Rubber Avenue Reconstruction FY24-B057 NAUGATUCK, CONNECTICUT

ADDENDUM NO. 2

7-6-23

UT-1
SHEET OF

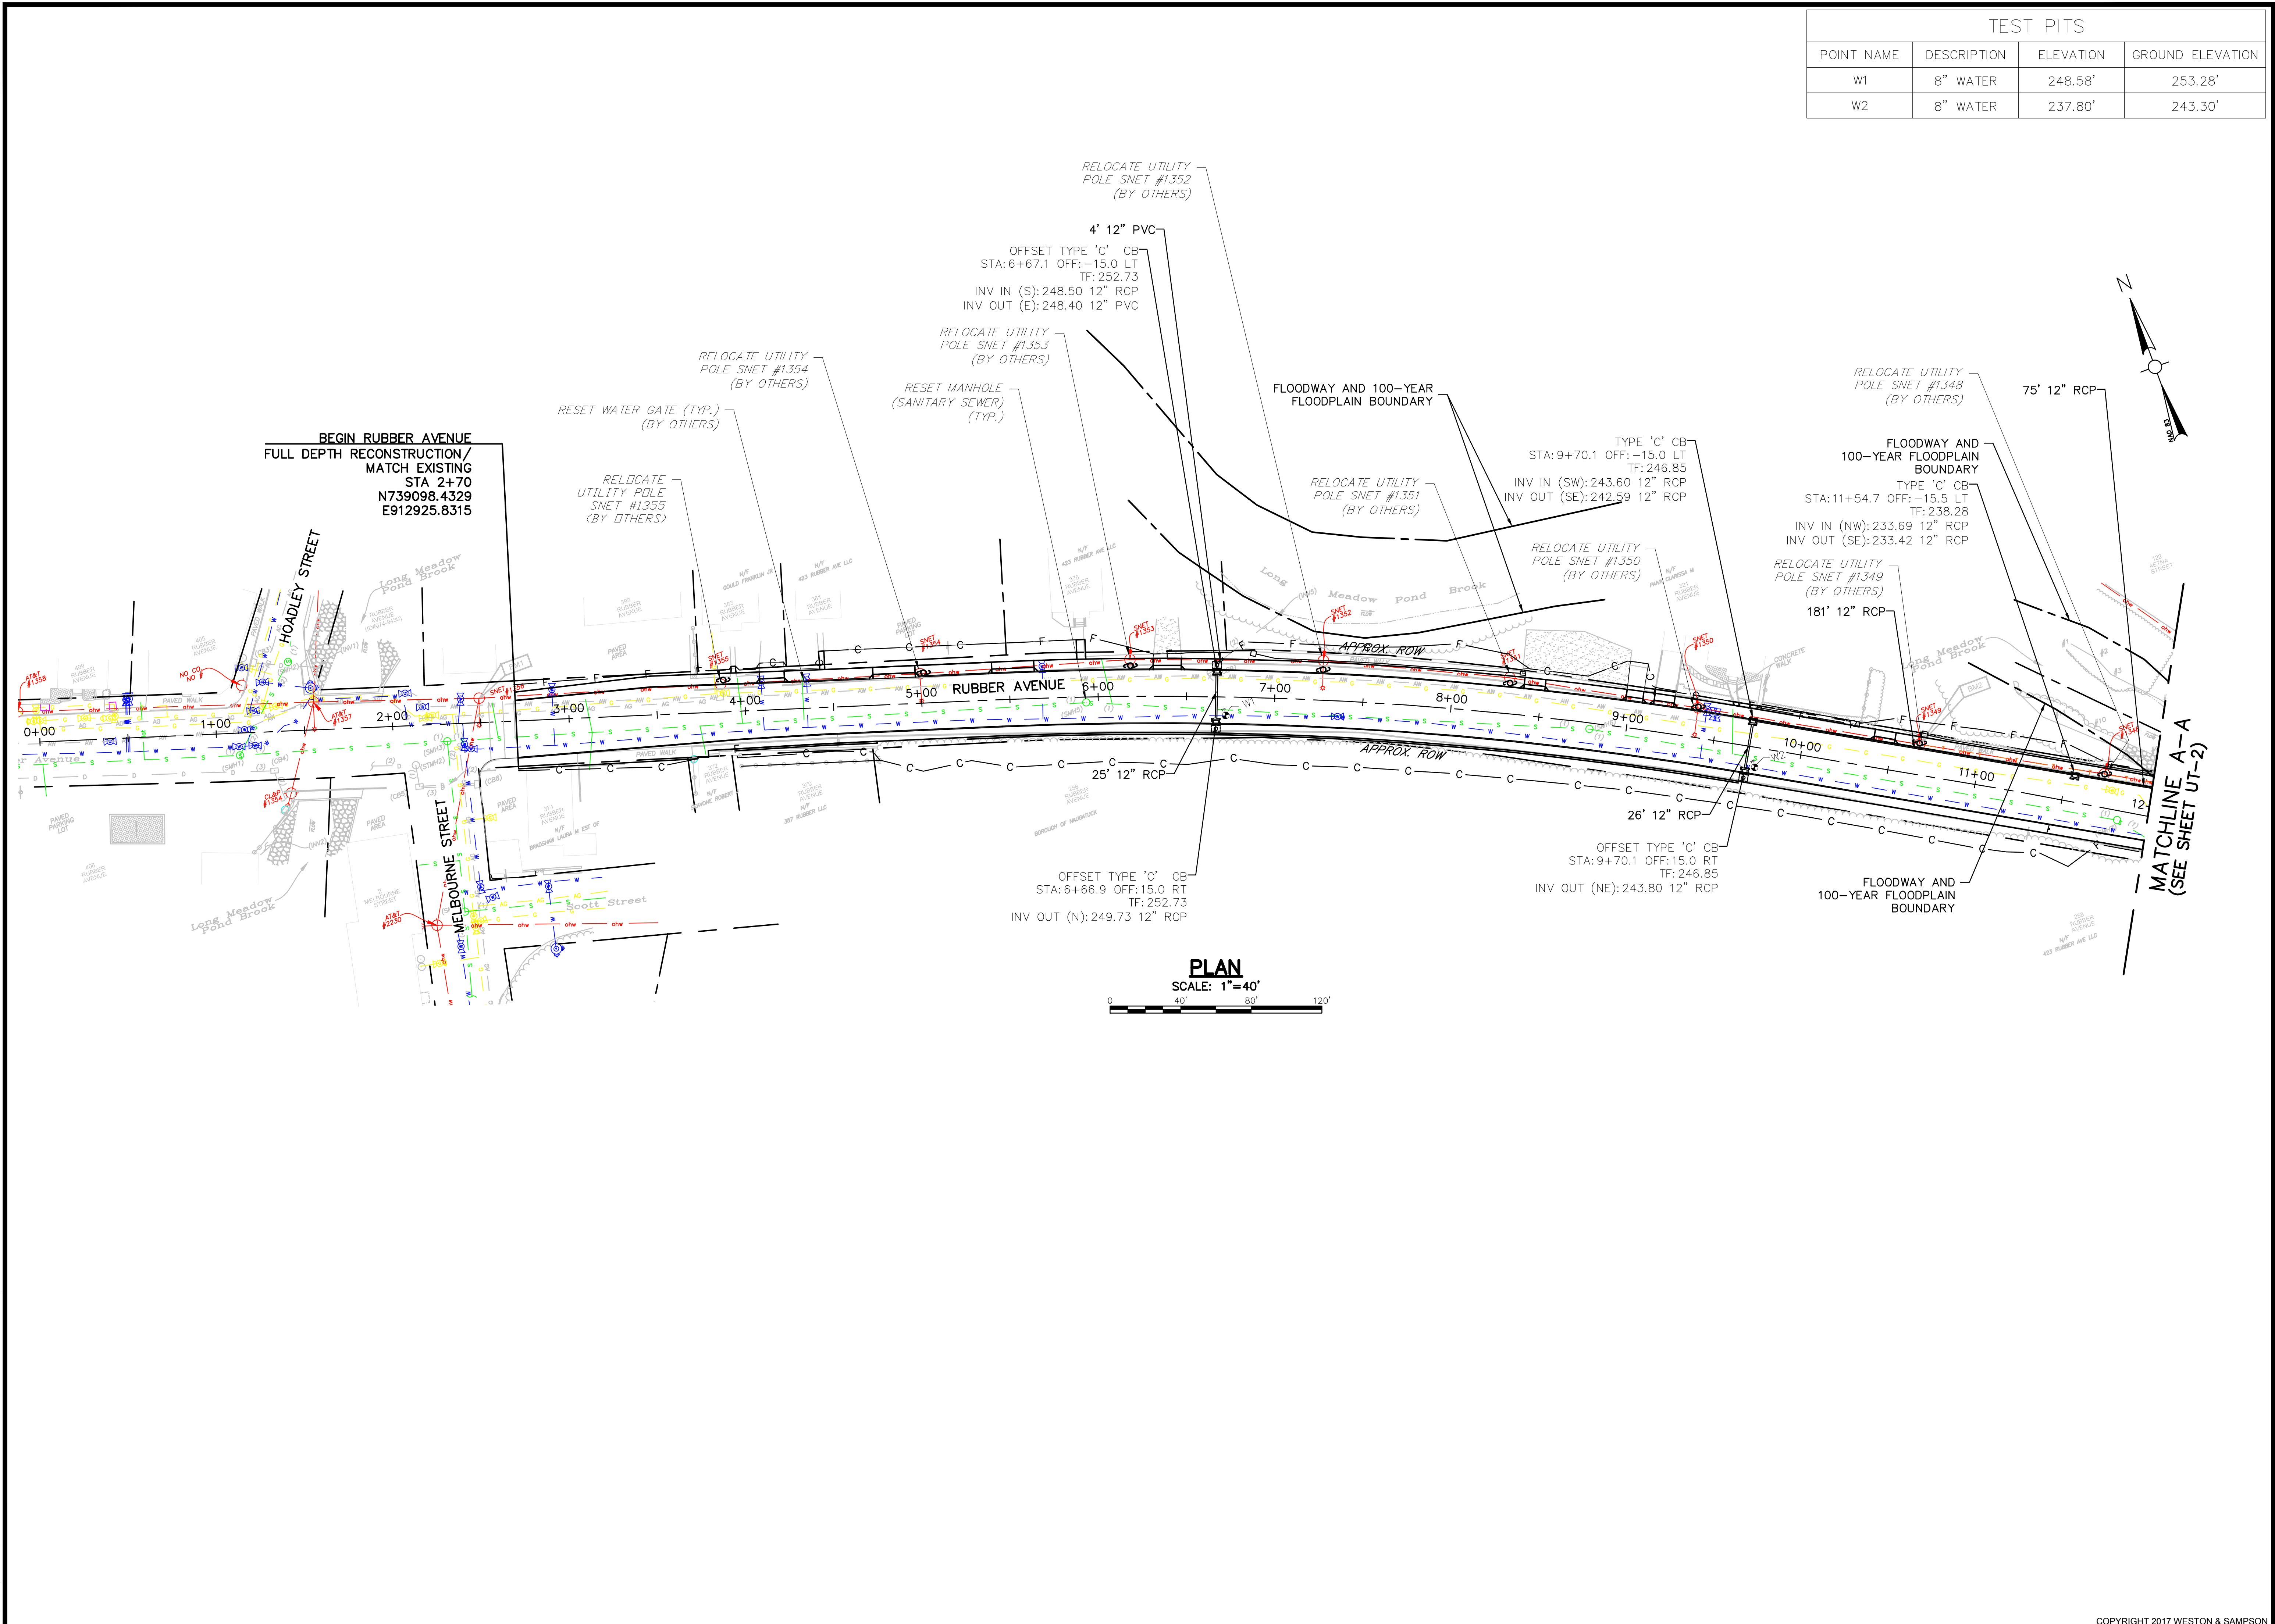
- k. Is it possible to provide drainage only plans for this project? This info. is combined with Utility Relocation Plans and they are extremely cluttered and difficult to decipher what is going on. Also, none of the drainage structures are numbered. Does any of the info. shown on UT-5 Sheet 41 of 115 pertain to the new drainage system? Where are all these structures shown in relation the new drainage system?

- aa. There are notes on the Utility Plans UT-1 through UT-4 that say Reset Water Gate (TYP) by others. Does this mean that bid item #1302053A will be deleted?

Response: See attached and updated UTILITY drawings which remove the unnecessary utility relocation notes.

Response: Yes. This item will be deleted. See Revised Bid Proposal Form
